Phantom Landfill/PH3

Solid Waste - Correspondence - Enforcement - Response to Letter,
Request Status Update for Compliance Order on Consent #08-08-15-01,
September 17, 2010

KRW CONSULTING, INC.

Subject: Response to letter "Request Status Update for Compliance Order on Consent #08-08-15-01", September 17, 2010
KRW Project No.: 9110-03

Boring No.: TH-20
Logged By: B. Tilton
Sheet: 1 of 5

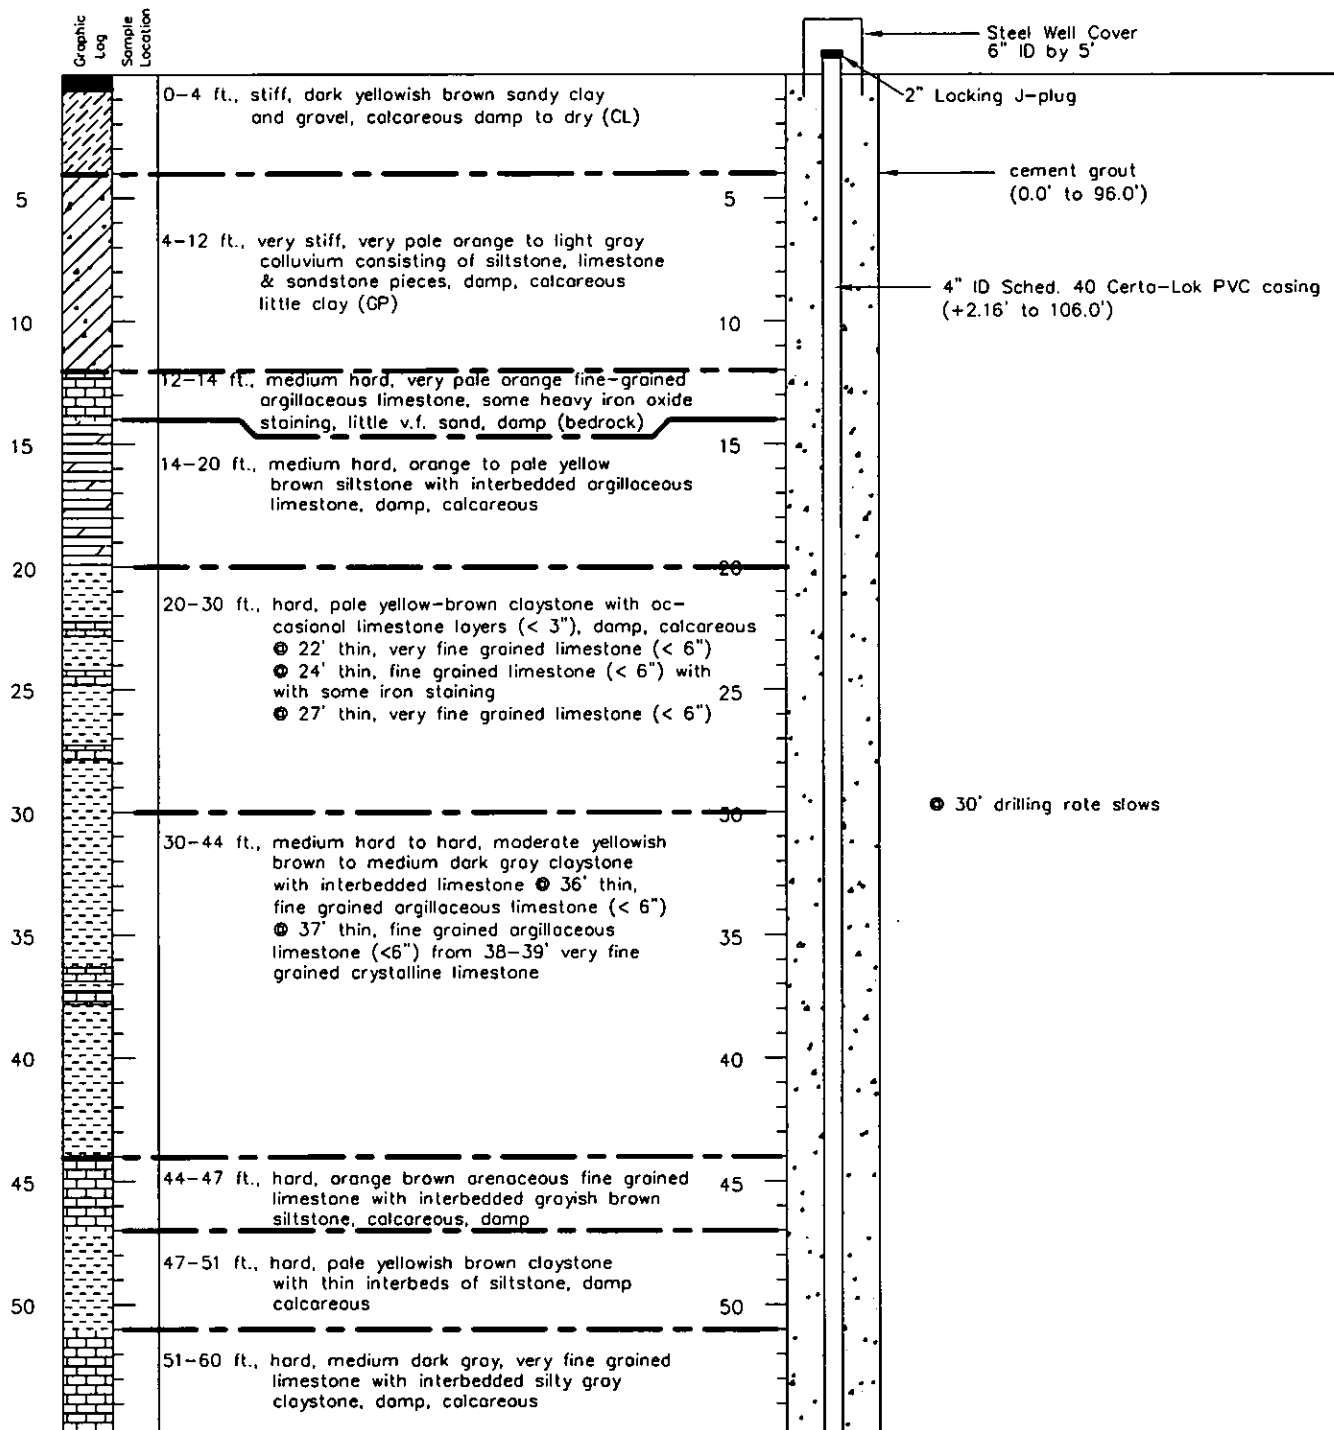
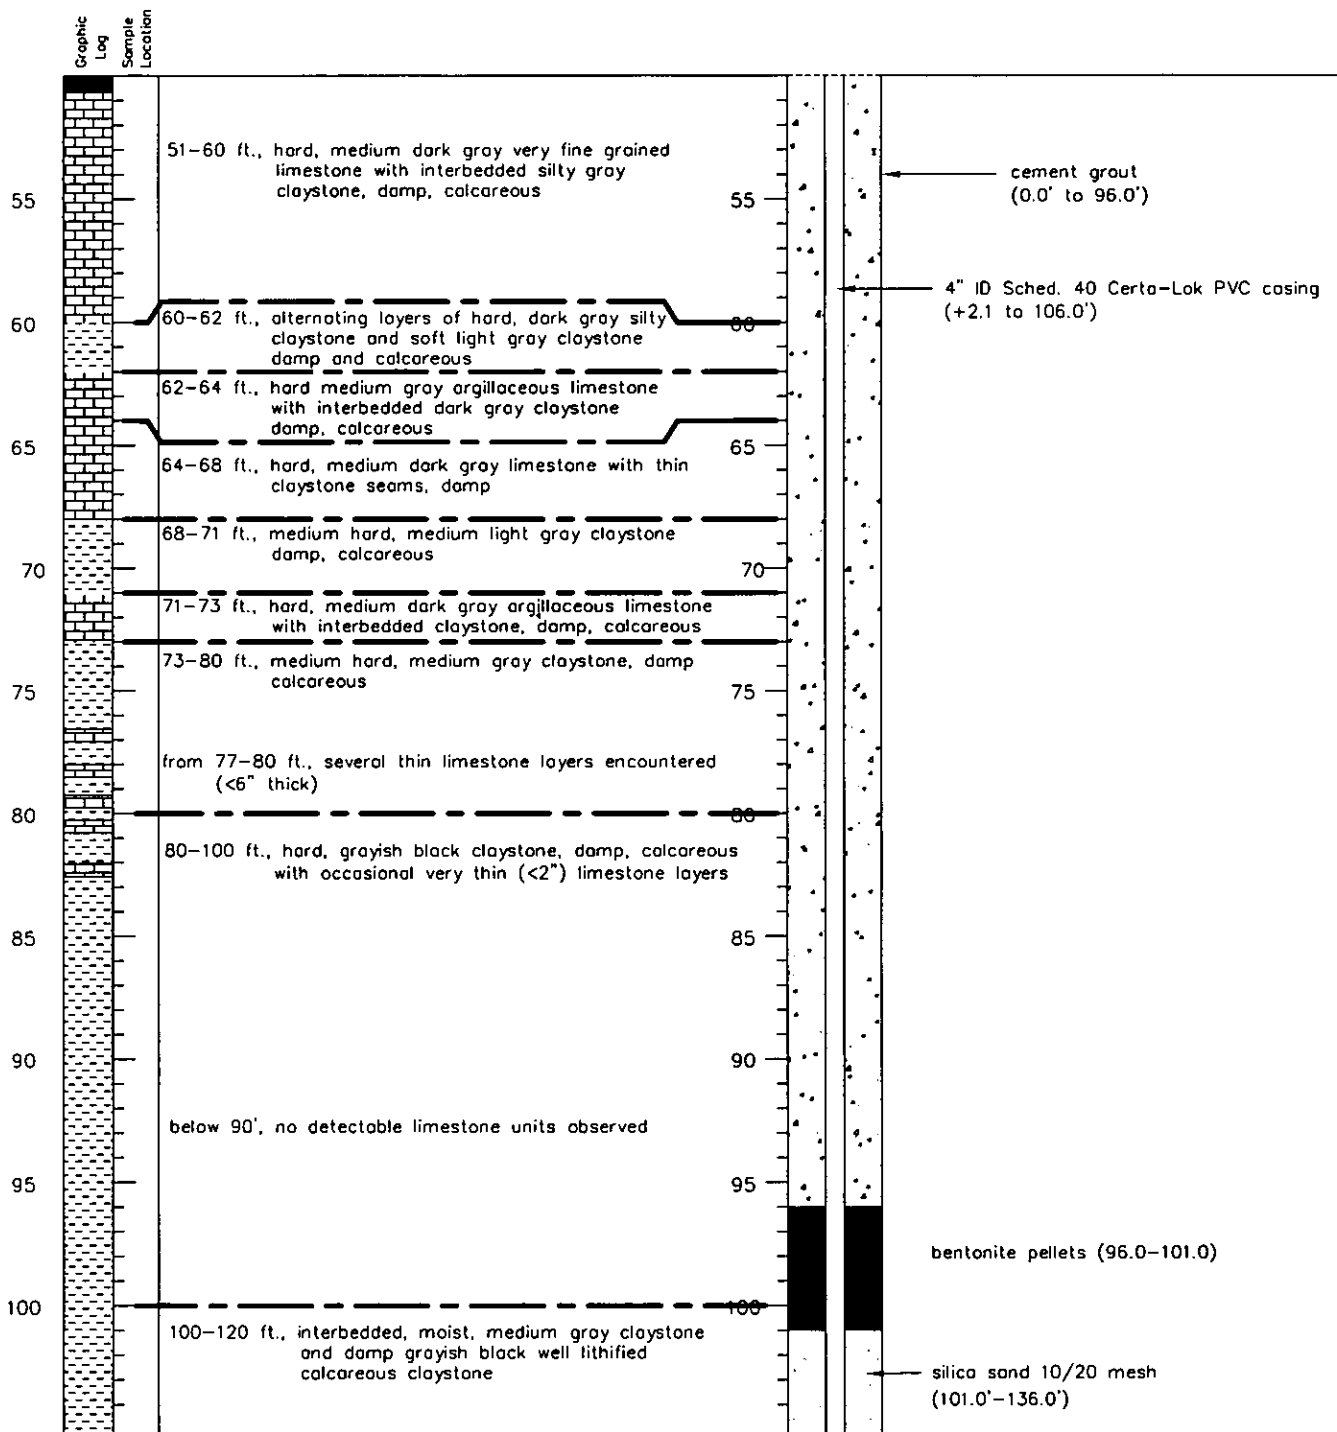
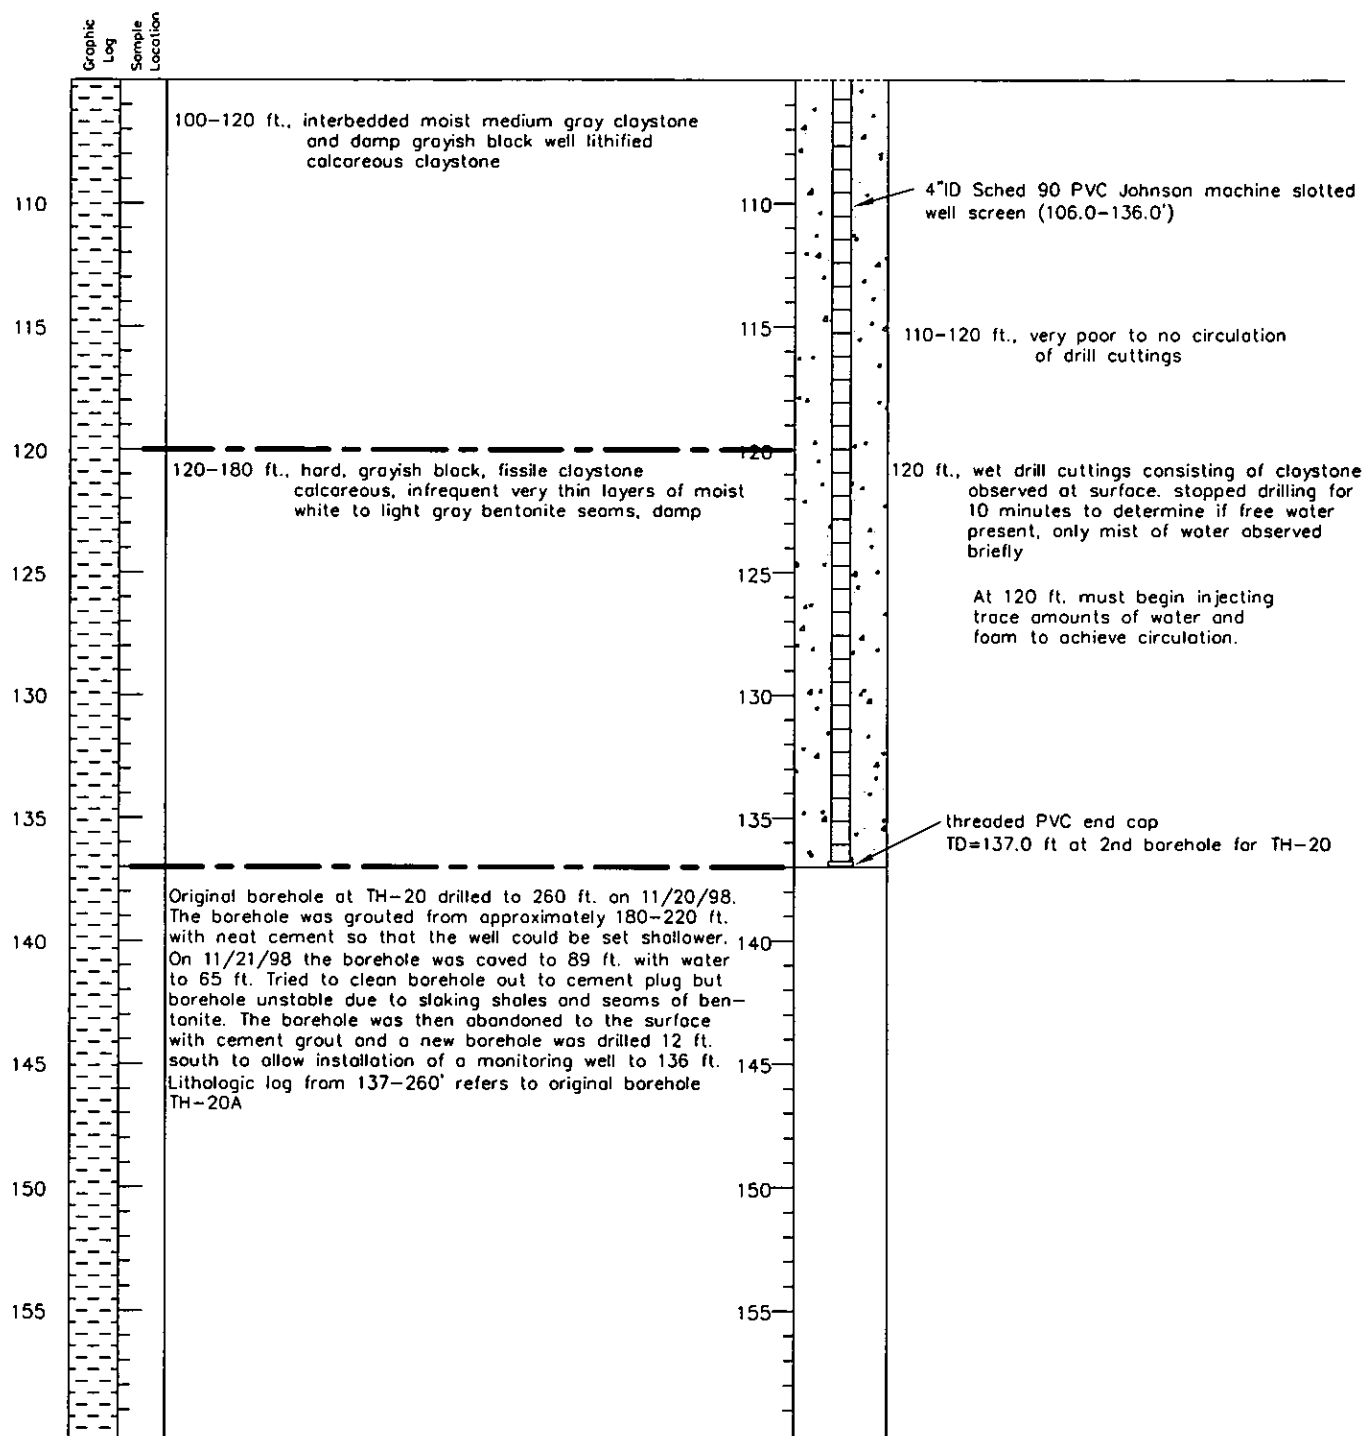
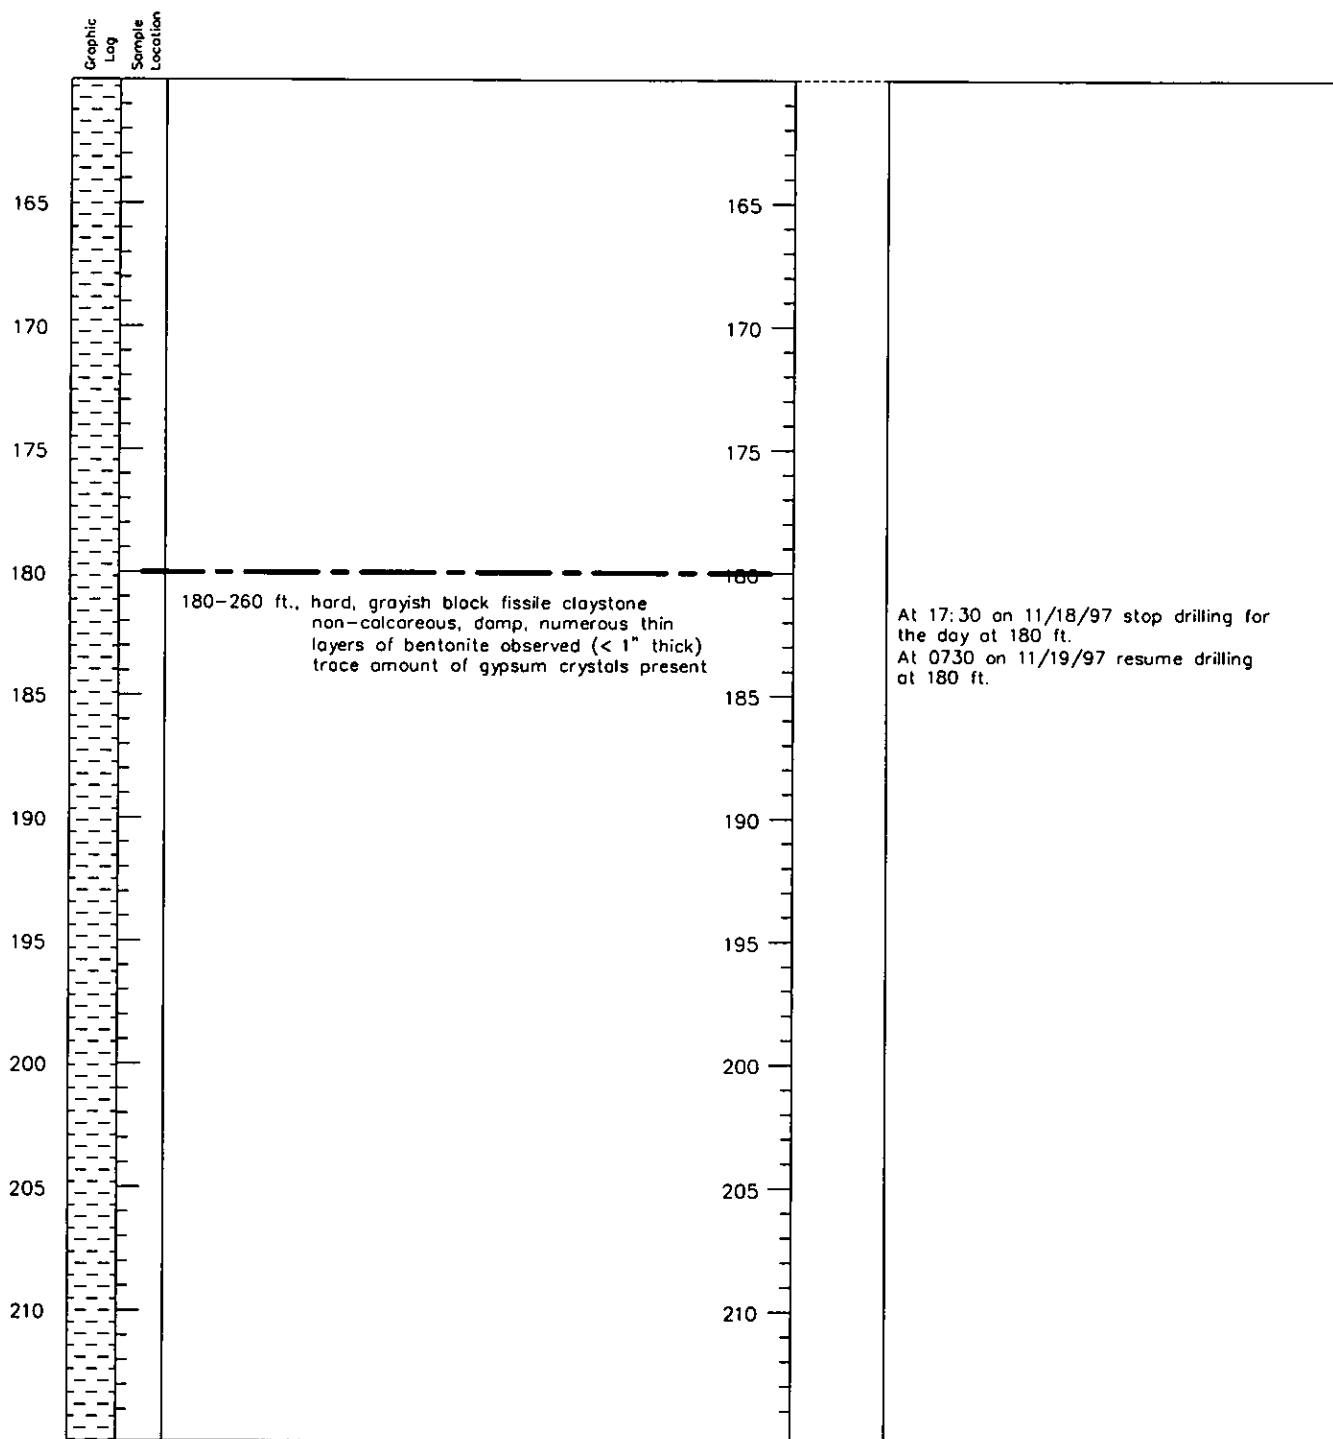
1. **Submittal of proposed assessment plan for the detailed hydrogeologic investigation necessary to modify the groundwater monitoring plan, with location and design of additional groundwater monitoring wells appropriate to the solidification basin, subject to Division review and approval (paragraph 32 of the Order).**

TWIN has performed a detailed analysis of the hydrogeologic conditions in the vicinity of the solidification basin and will implement changes in the Groundwater monitoring plan as appropriate. The hydrologic conditions beneath the solidification basin, as indicated by the nearest boreholes at the site, TH-9 and TH-20, indicate that there is no unconfined groundwater beneath the basin. The first aquifer to be encountered beneath the facility is the Greenhorn Limestone. Water was encountered in well TH-9 at a depth of approximately 91 feet and effectively screened in the uppermost water bearing zone between 90 and 105 feet below ground surface (BGS). Subsequent water level measurements in this well indicate a water level of less than 65 feet BGS. Water was encountered in well TH-20 at a depth of approximately 100 feet and effectively screened in the uppermost water bearing zone between 101 and 137 feet BGS. Subsequent water level measurements in this well indicate a water level of less than 50 feet BGS. Since this is clearly a confined aquifer, the aquifer is not a potential target for contamination from the facility. The site plan/geologic map (Figure 1) and well logs for TH-9 and TH-20 are included as attachments to this letter.
